41-3 ST. LAWRENCE STREET

CITY OF PORTLAND, MAINE

43 St. Lawrence St.

43 St Lawrence

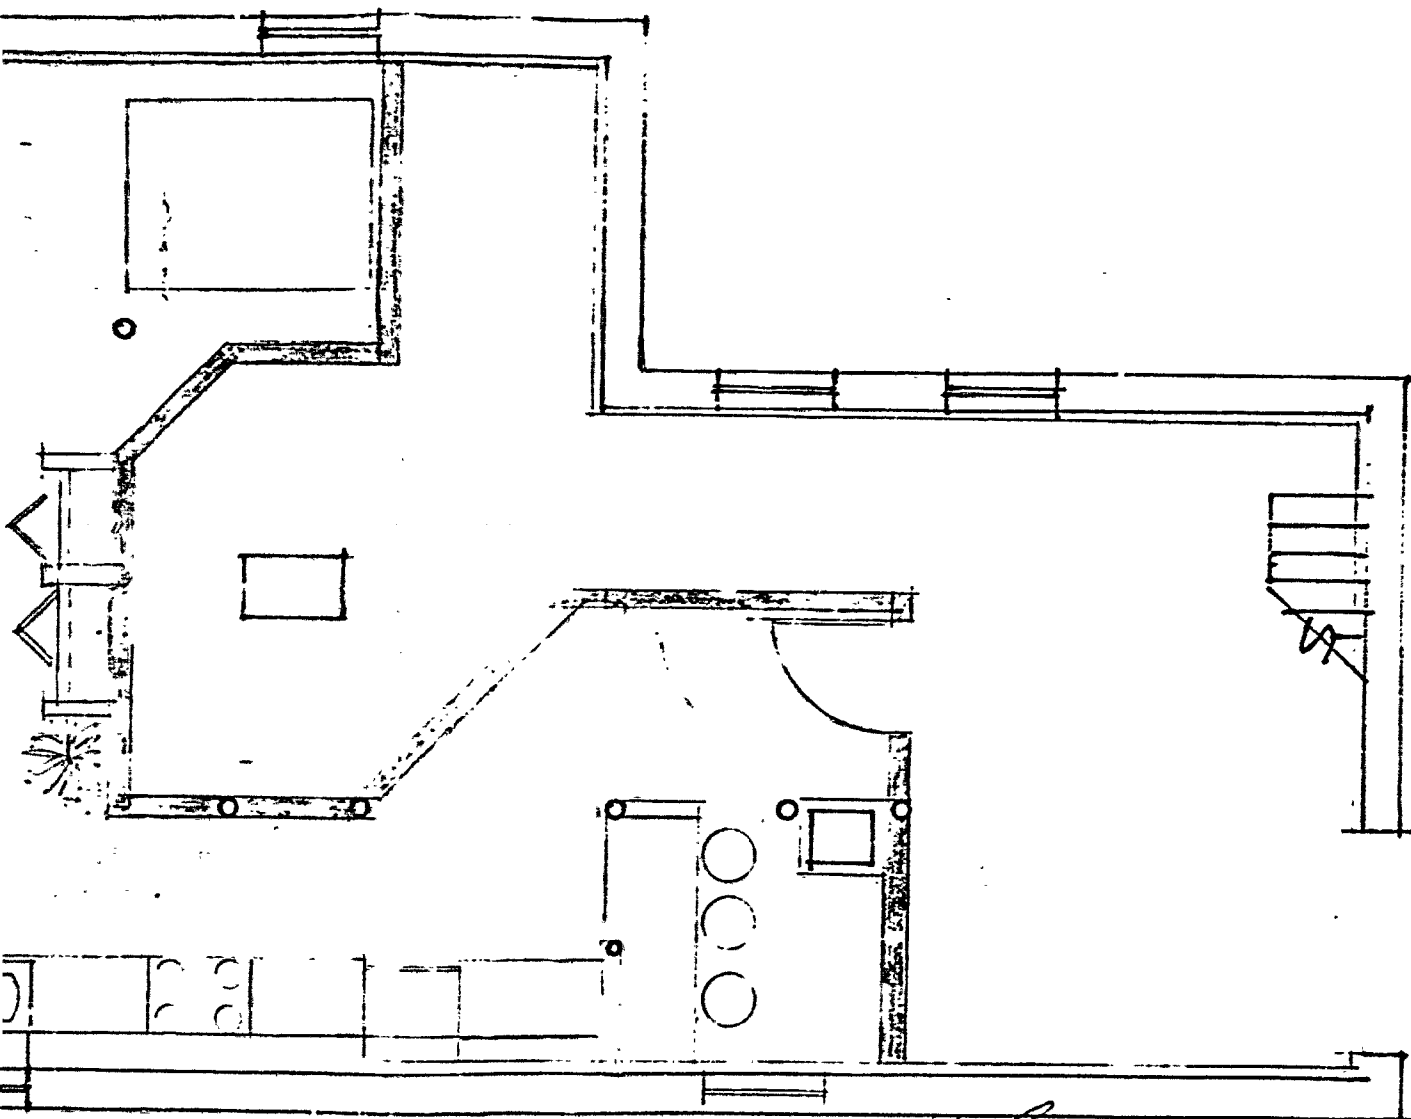
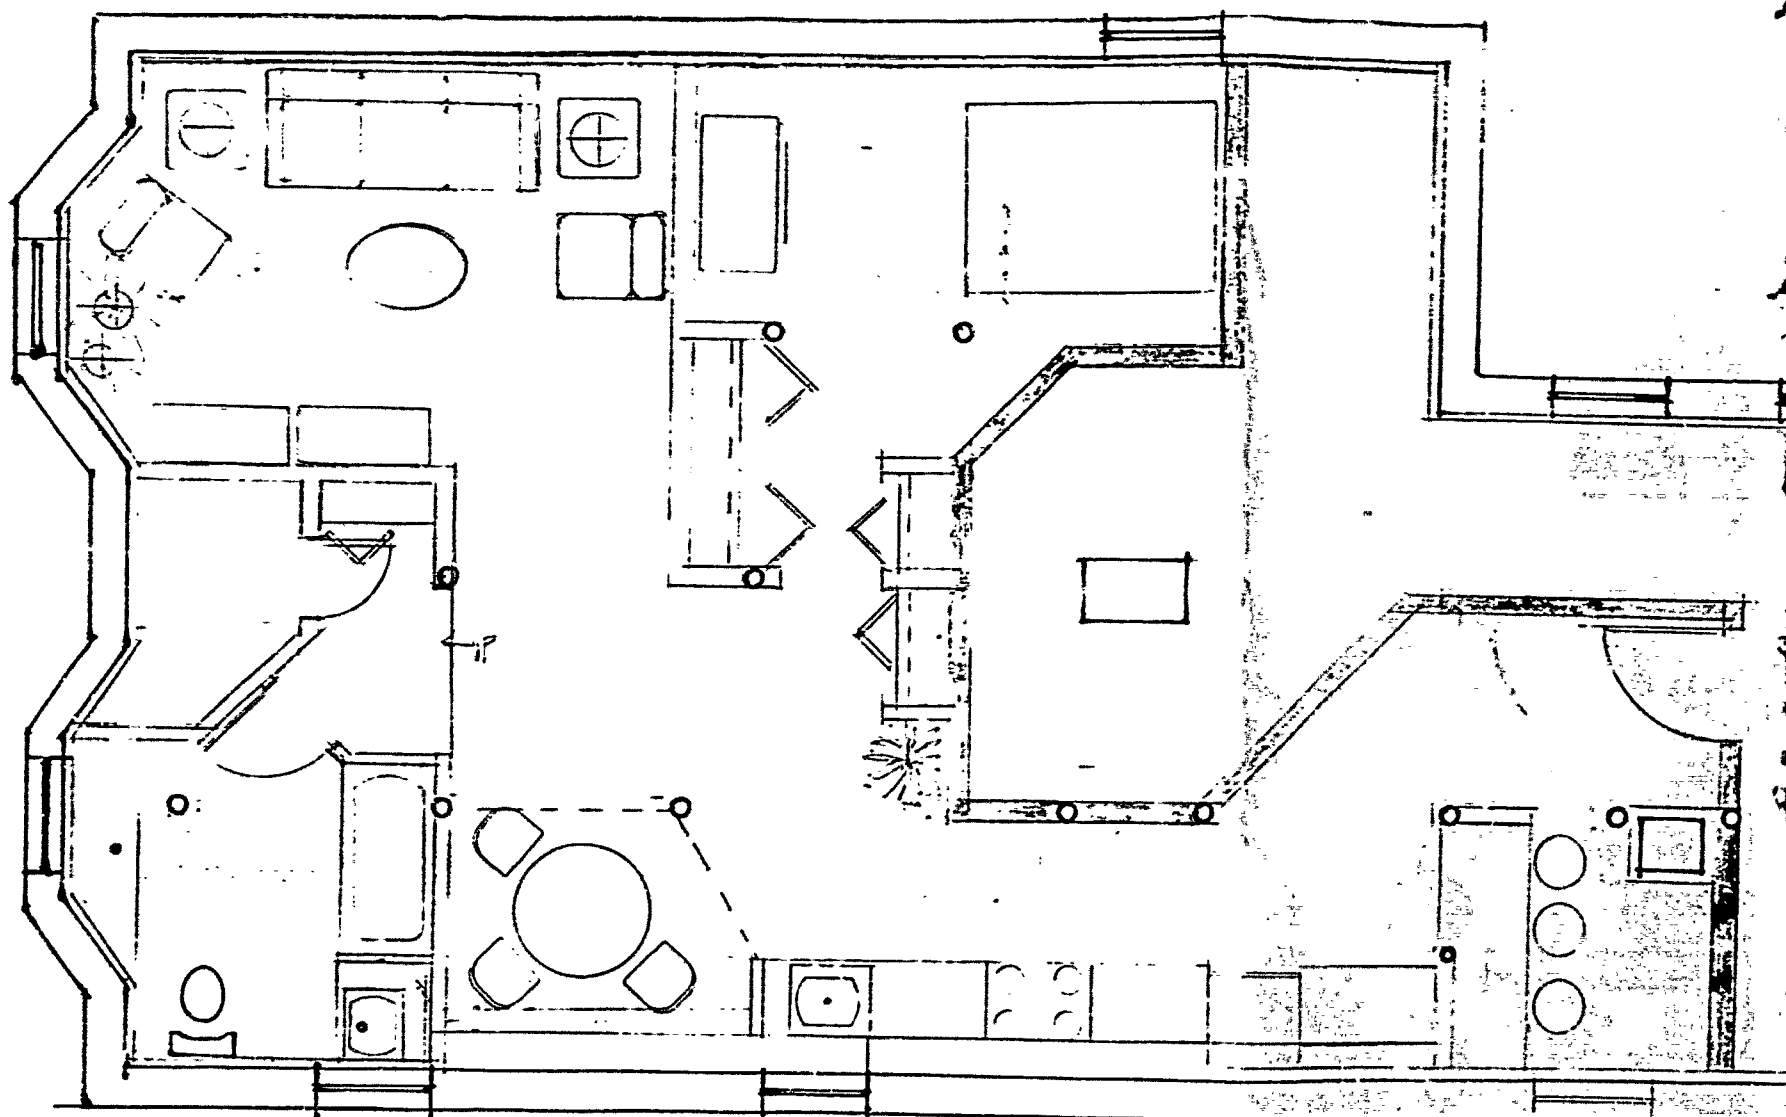
Please furnish this office with some details concerning the room sizes and overall dimensions of the plan which you submitted for basement apartment unit. We will also need to know if the windows are sufficiently large enough to meet the life safety and fire prevention codes.

Please let us know if your plan for a basement unit complies with the minimum floor area and the minimum size windows for compliance with the Life Safety Code and BOCA Building Code, which the City of Portland uses for construction purposes.

3 - Window size - 10" x 30"
Floor space for basement unit. approx. 720 sq ft.
